**BEFORE THE PUBLIC UTILITIES COMMISSION OF THE STATE OF
CALIFORNIA**

Application Of Southern California Edison
Company (U 338-E) For Authority To Increase
Its Authorized Revenues For Electric Service In
2018, Among Other Things, And To Reflect
That Increase In Rates.

Application 16-09-001
(Filed September 1, 2016)

DIRECT TESTIMONY OF CURT VOLKMANN

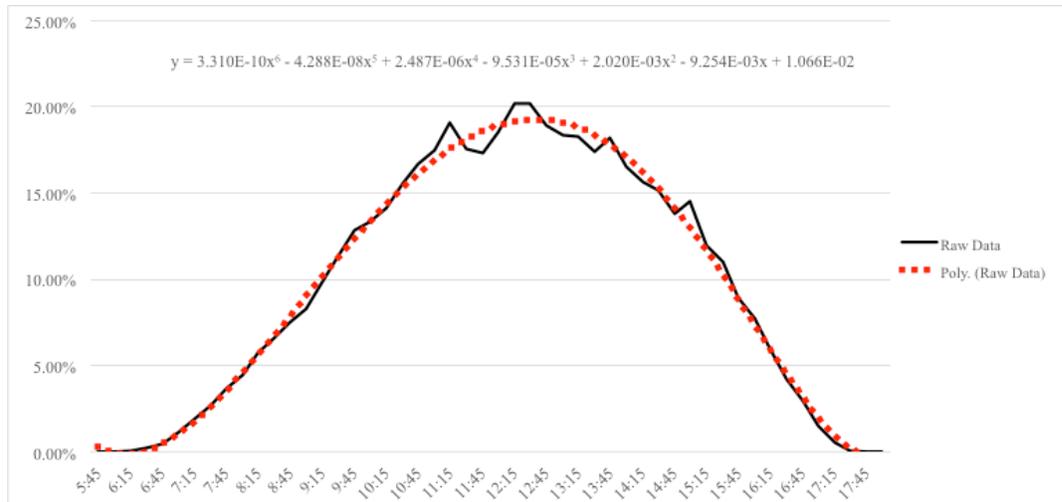
1 As I stated previously, as much as \$875 million of 2018-2020 capital in
2 SCE's GRC application is influenced by the PV Dependability values.

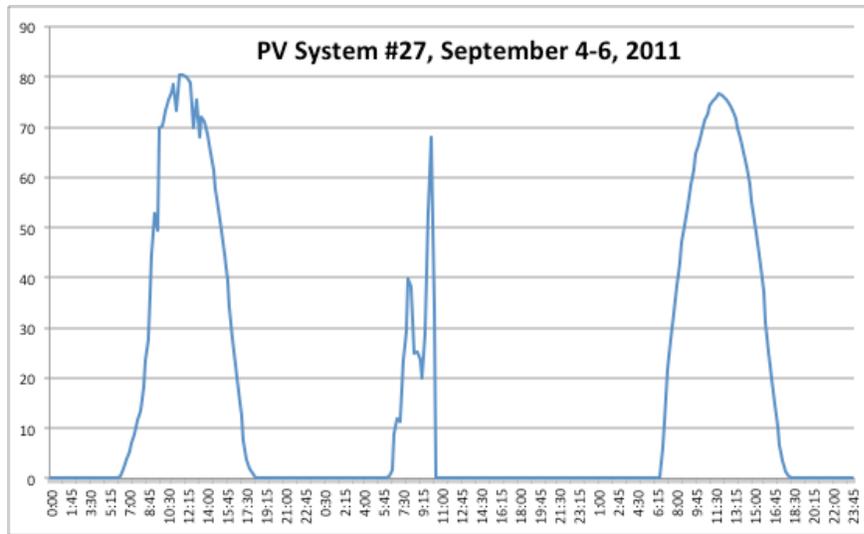
9 A. For many of the systems, the underlying PV output data consists of random
10 integers (“1” or “0”) for each interval.⁸¹ For other systems, recorded PV
11 output drops to zero at random times, resulting in a minimum output value
12 of zero from the system for all or most intervals.

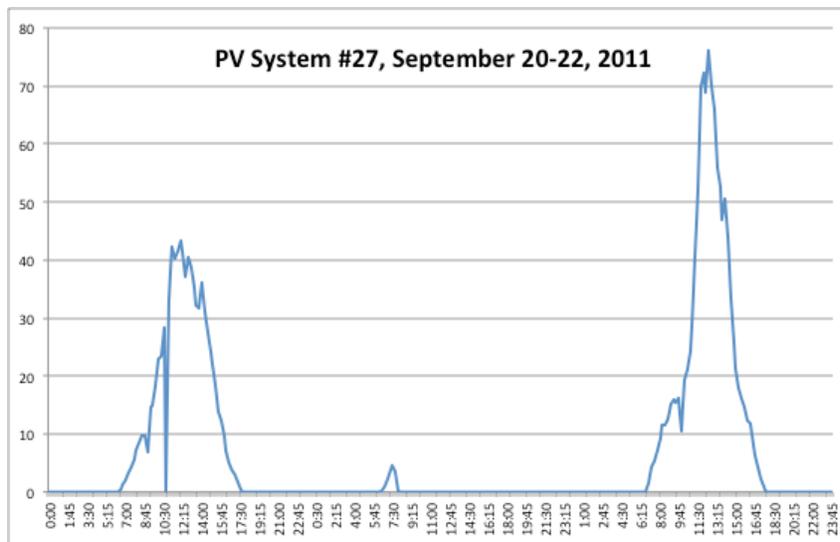
The recorded PV output also drops to zero at the 10:45am interval on September 20 and after 8:00am on September 21. Again, the data shows consistent, normal PV output for every other day in the Study Period. I believe these zero values do not reflect actual PV system output but rather bad data from the CSI meters not recording properly.

Figure I-3
Communications Programs

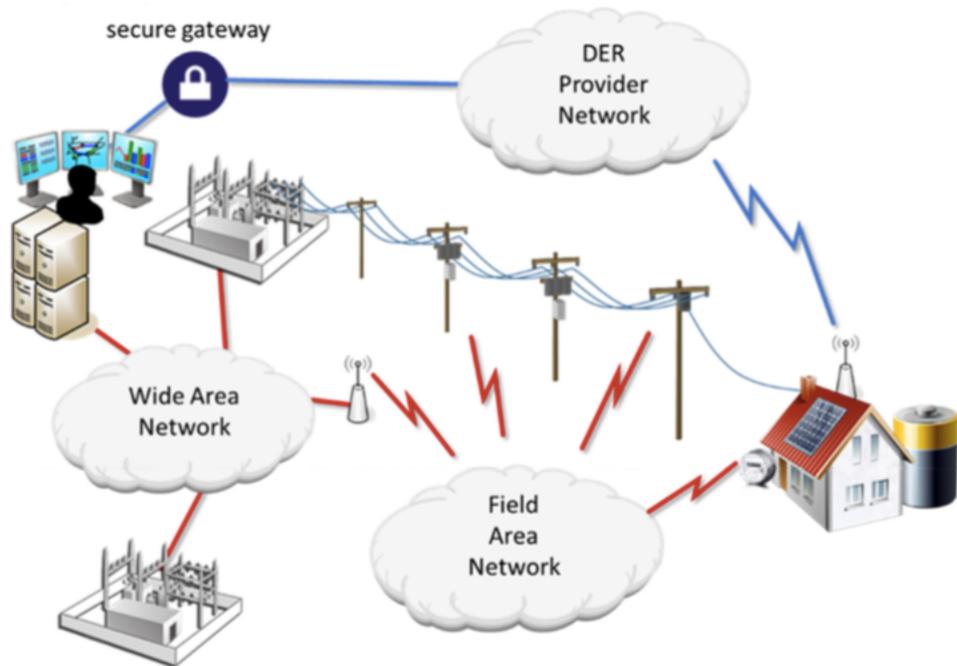
4 **A.** It’s difficult to determine. SCE includes a few diagrams in its GRC
5 application, such as the one below⁹⁴, that indicate exclusive third-party
6 interaction with DER.
